Caballeros De Oro Estates

CITY OF LAS VEGAS			DATE:	
INTER-OFFICE MEMORANDUM			November 14, 2016	
TO: Land Development Services Department of Building & Safety			FROM: Albert Sung, P.E.  Flood Control Project Engineer Department of Public Works	
SUBJECT: Drainage Study for: Caballos De Oro Estates			COPIES TO: Balova Engineering	
Cross Streets:	NWC of Cliff Shadows Pkwy & Buckskin Ave.		Caballos De Oro Estates, LLC	
File Number:	F:\Depot\DSMemos\DS4811C.doc		Bart Anderson, P.E., DevCo	
Parcel Number:	137-12-301-009		CCRFCD	
Zoning Action:	SDR-XXXXX etc.		CCPW	
FEMA Flood Zone	YES	NO	X	
Proposed Storm Drain	YES	NO	X

TECHNICAL DRAINAGE STUDY

SUBJECT: TECHNICAL DRAINAGE STUDY FOR CABALLOS DE ORO ESTATES
CLV DS 4811A / RFCD16-9732
Supplement

C4

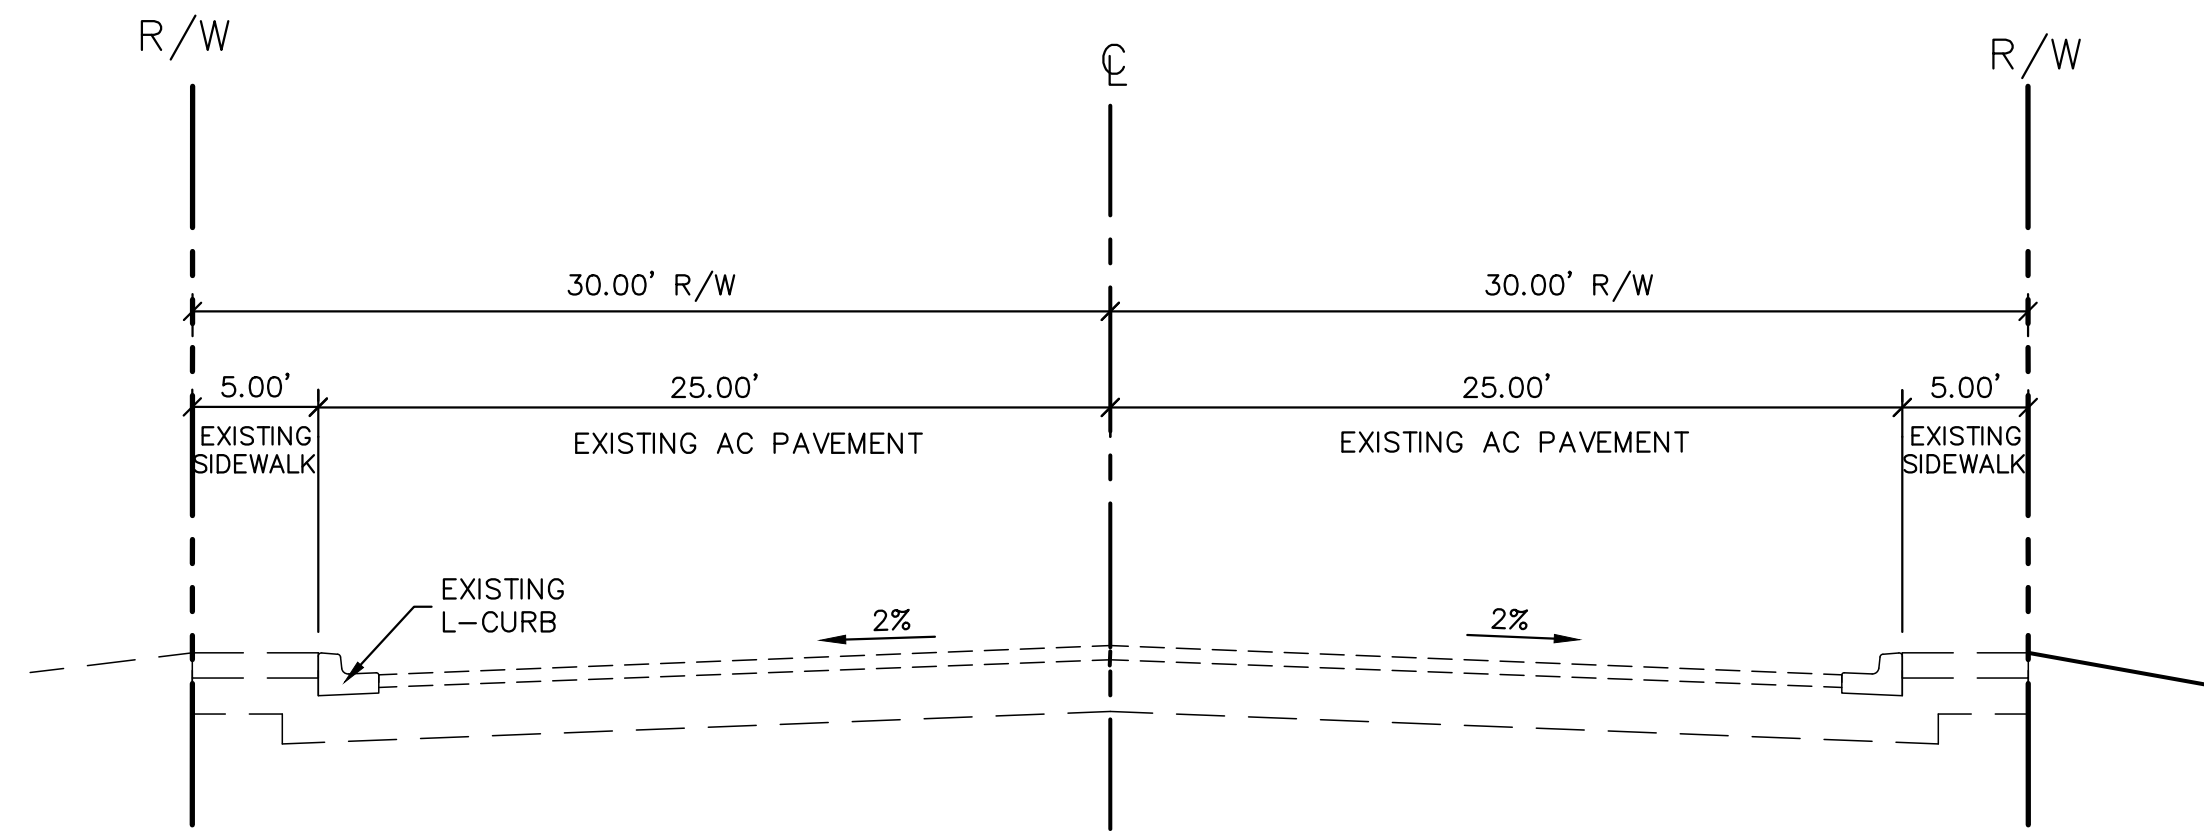
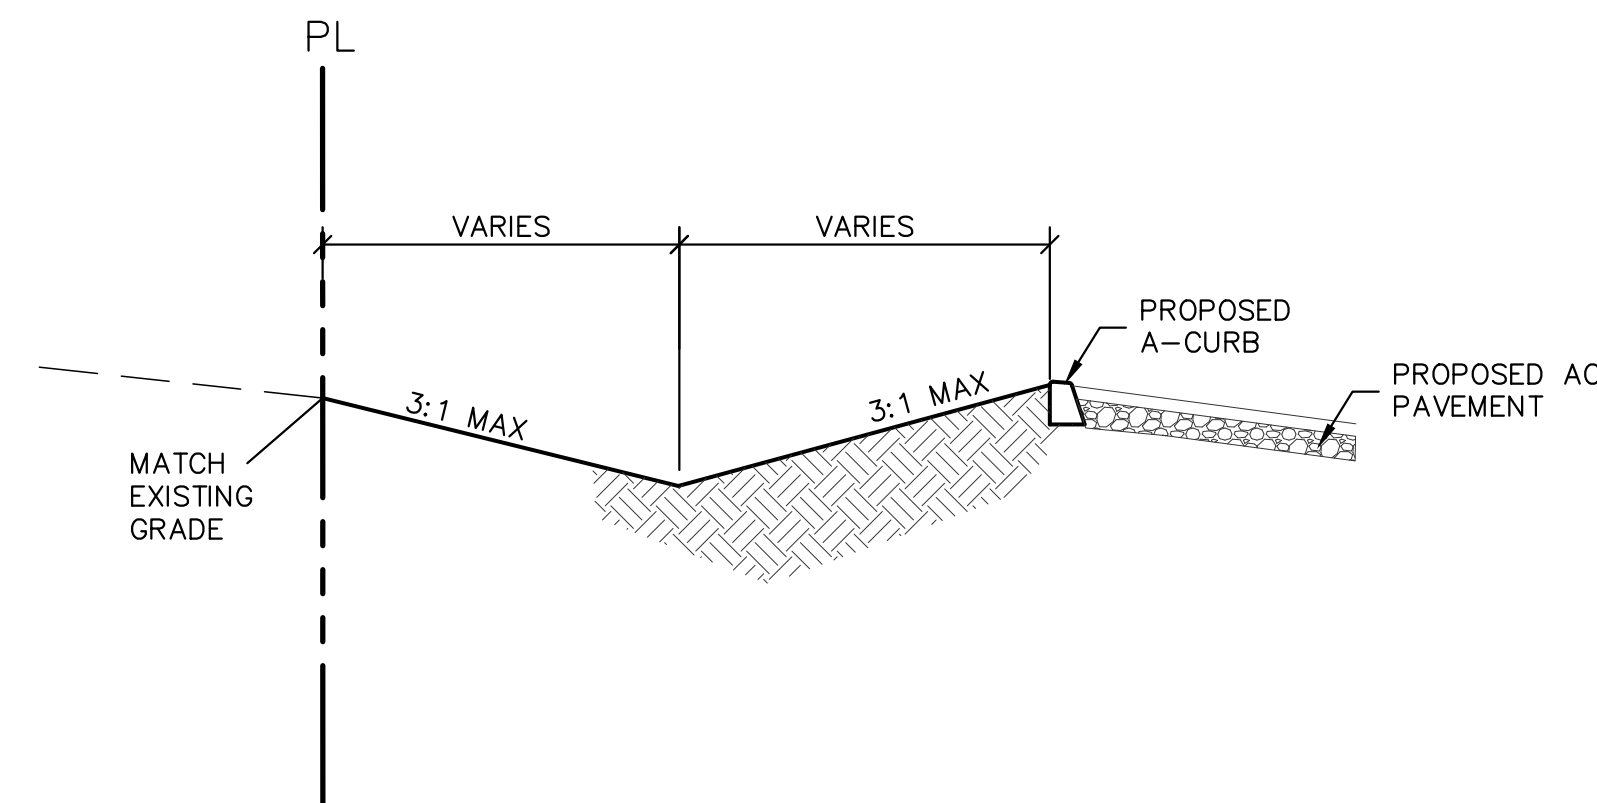
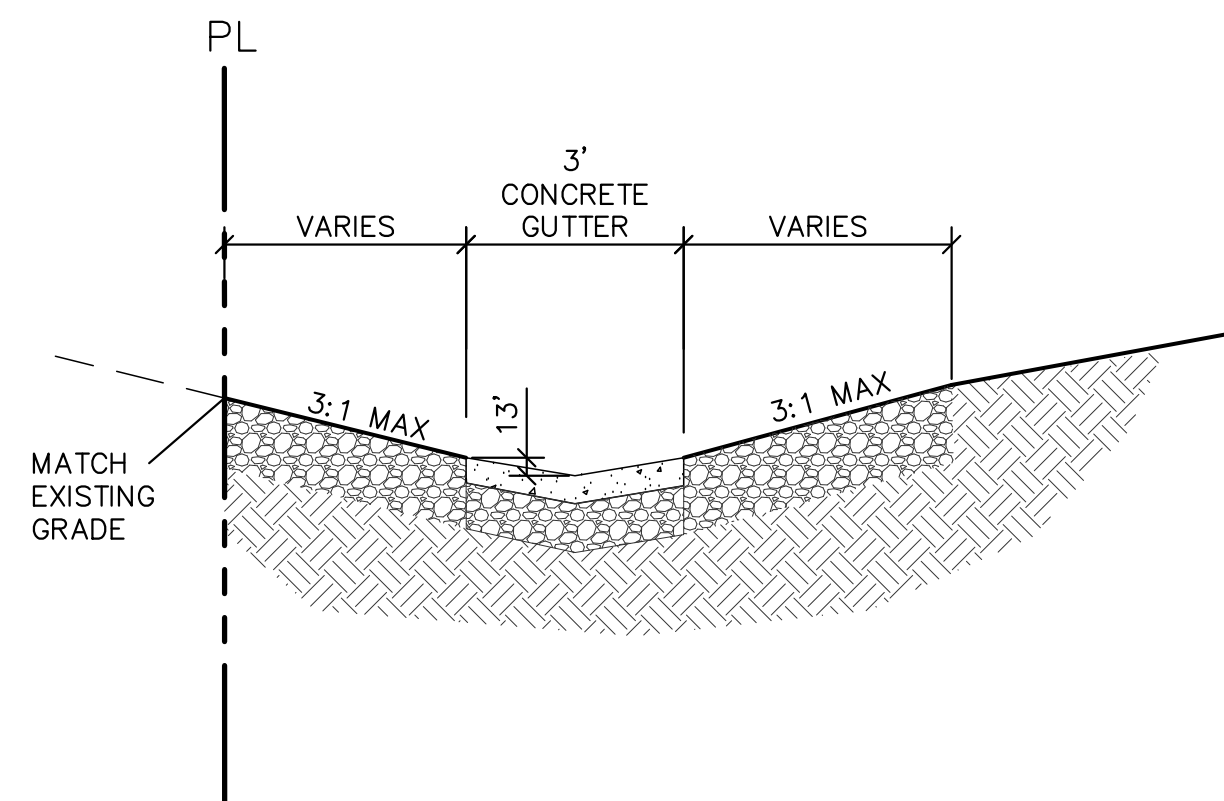
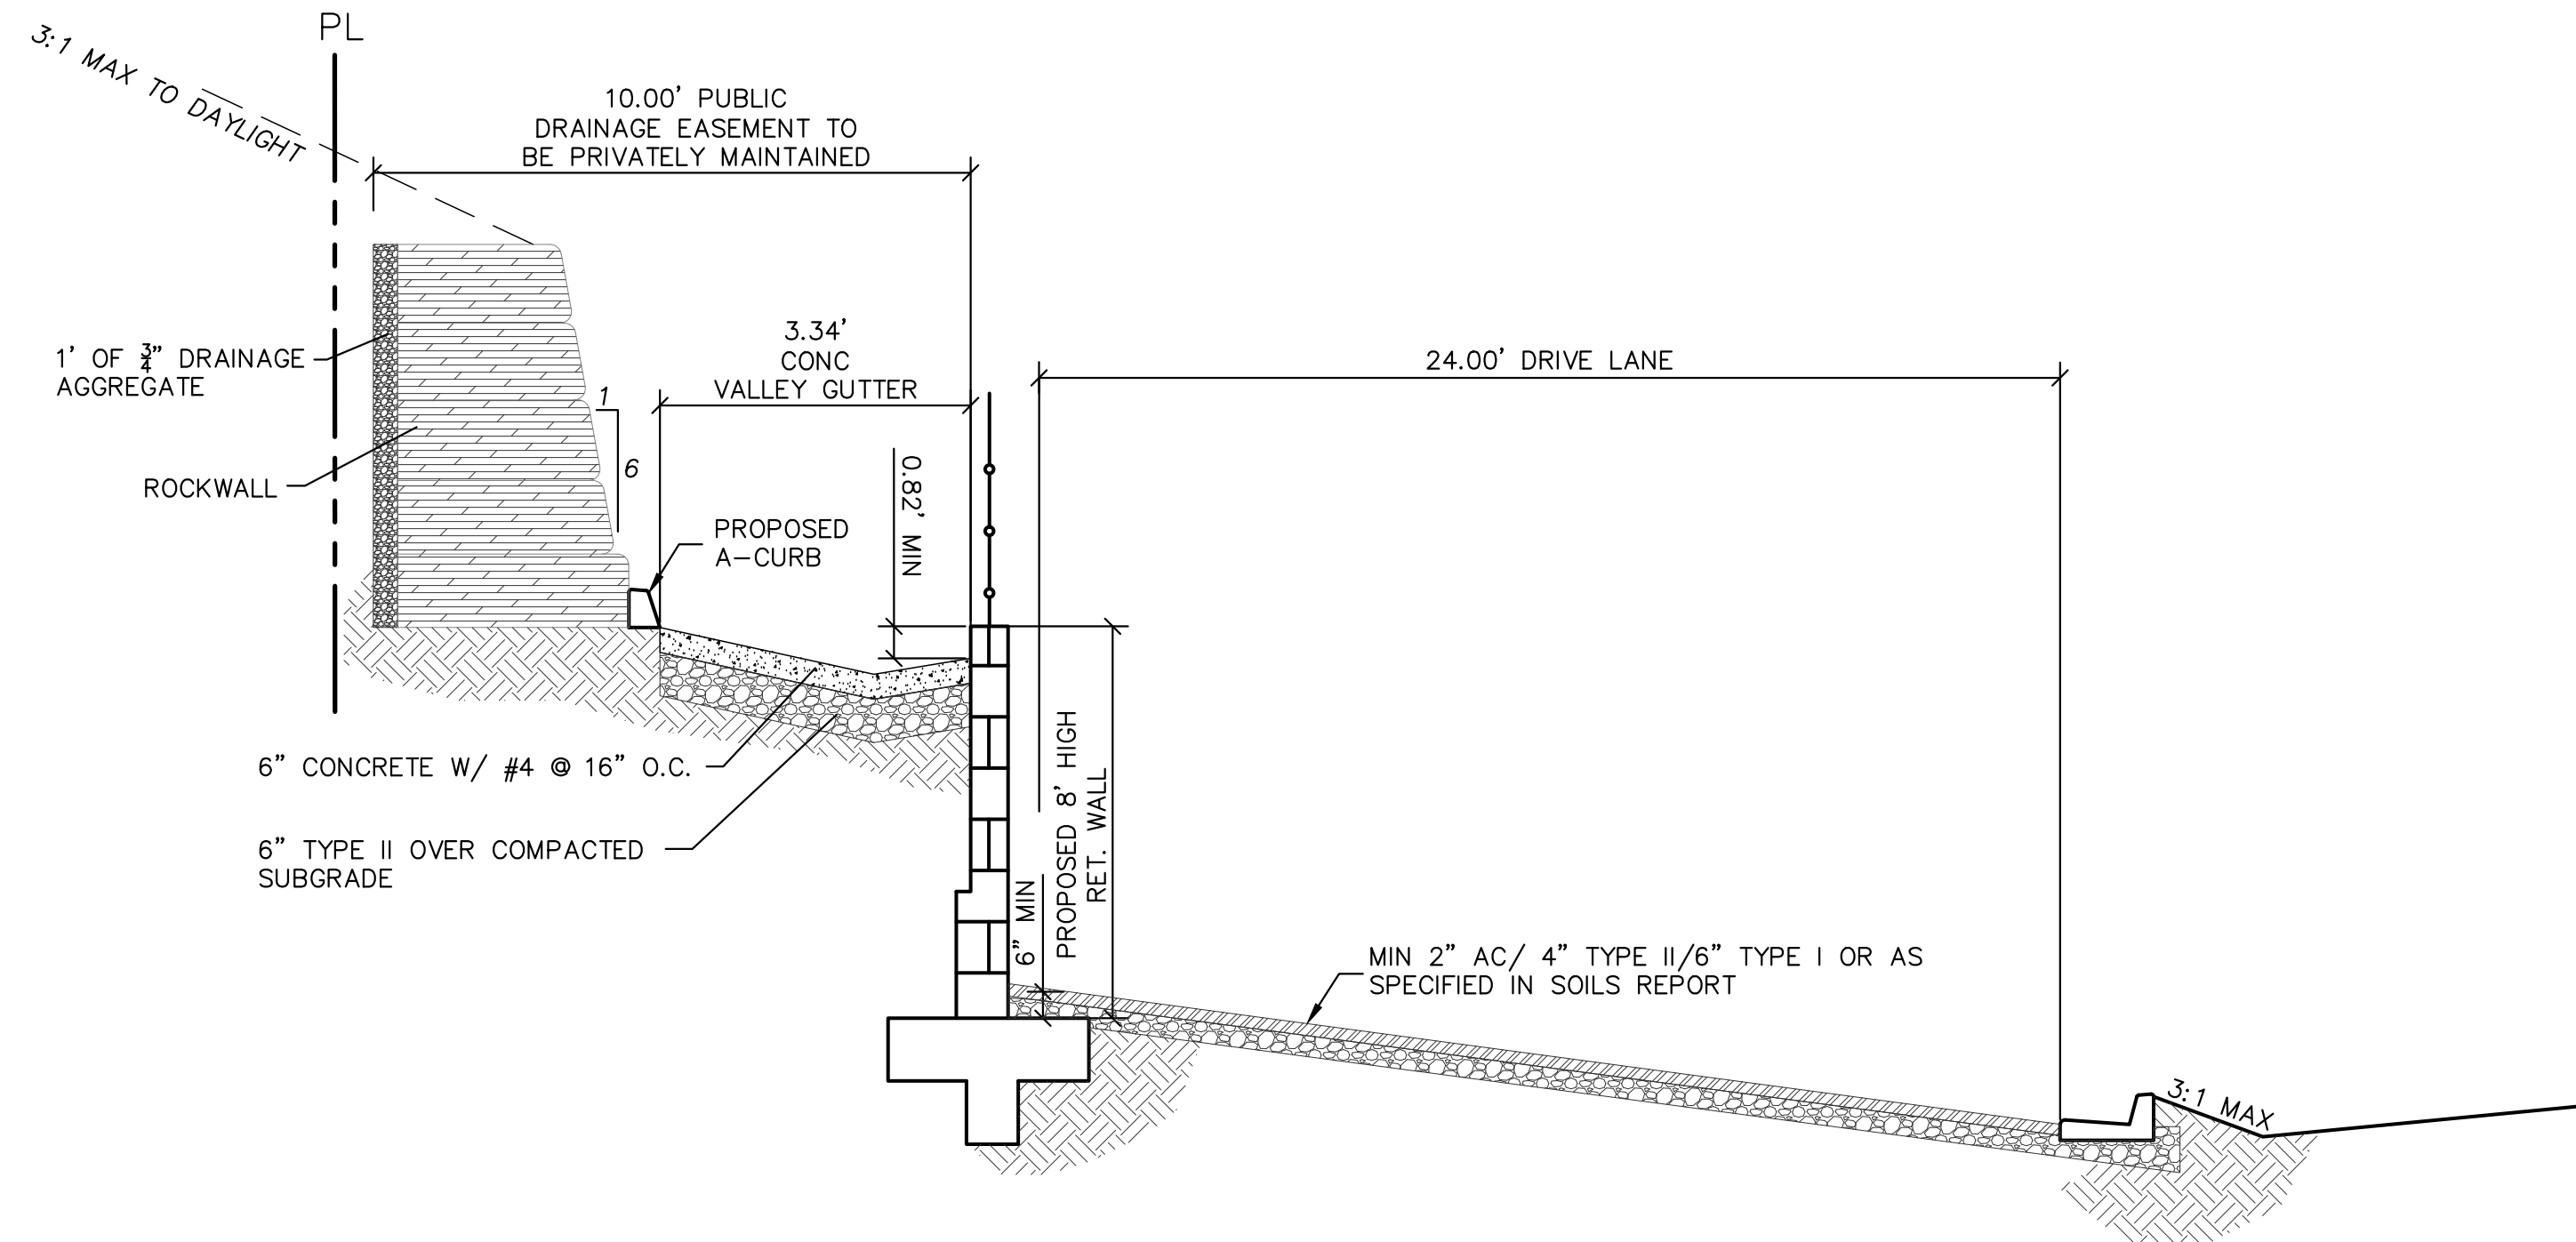
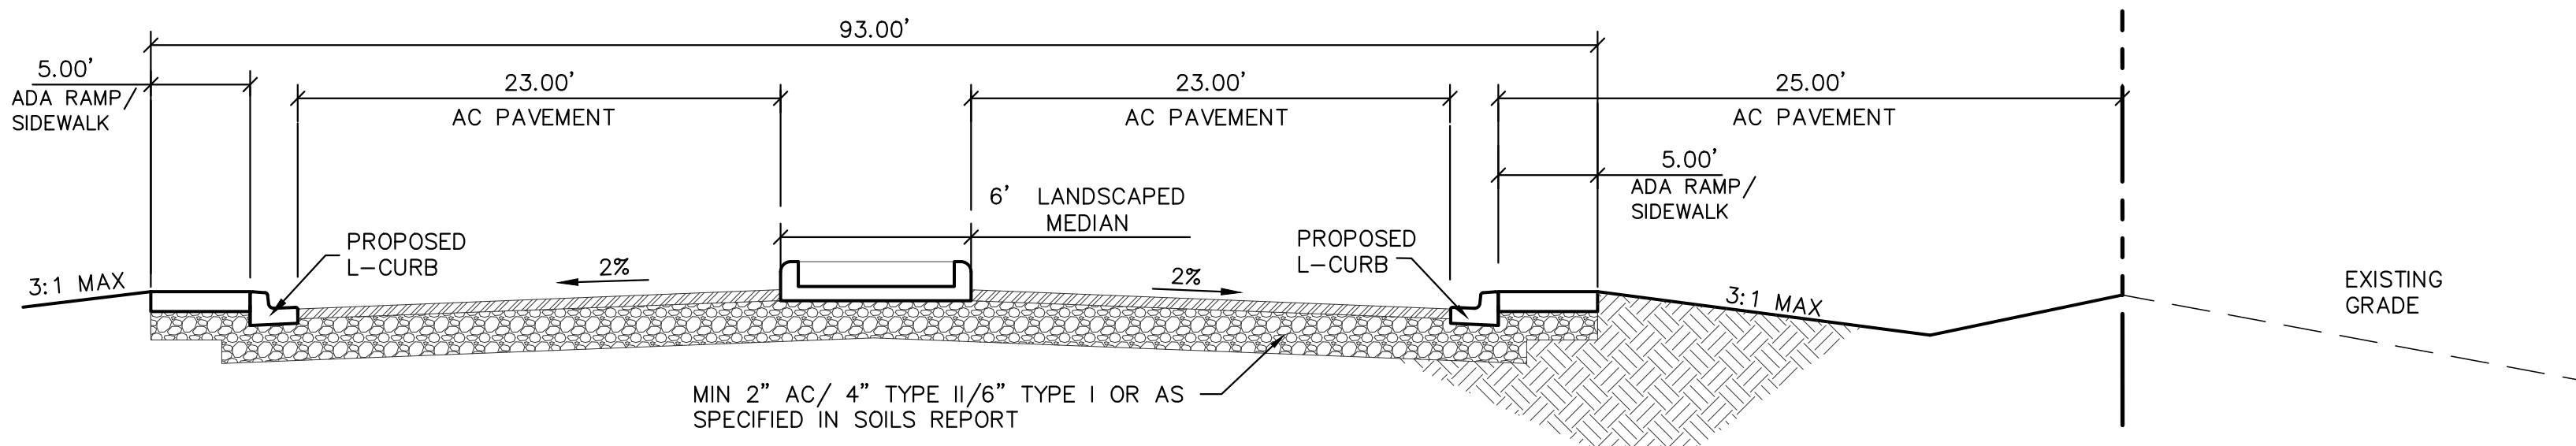
The District would like to see an additional detail cross section where it ties into GOL40026 and provide 3-ft cutoff walls along this section.

Additionally, delineate drainage easement on C/C4 and correct typo on I/C5. If you can provide supplement plans to us and the City, we will be able to provide District concurrence.

- A cutoff wall was added and a cross section was shown sheet C4.
- The drainage easement was delineated on sheet C4.
- Type was corrected on C5
